SUBJECT: QT 7001 Traffic Impact Study  
Southwest Quadrant of Unser Blvd. and Los Volcanes south of I-40  
Albuquerque, New Mexico

The NMDOT received the QT 7001 Traffic Impact Analysis July 2024. District Three's comments are below.

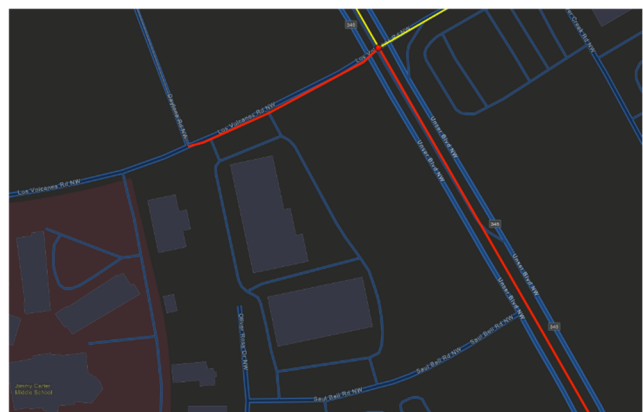
Page 45 – Please include HFIN map in your write-up, see example to the right. How will this development avoid contributing to these conditions?
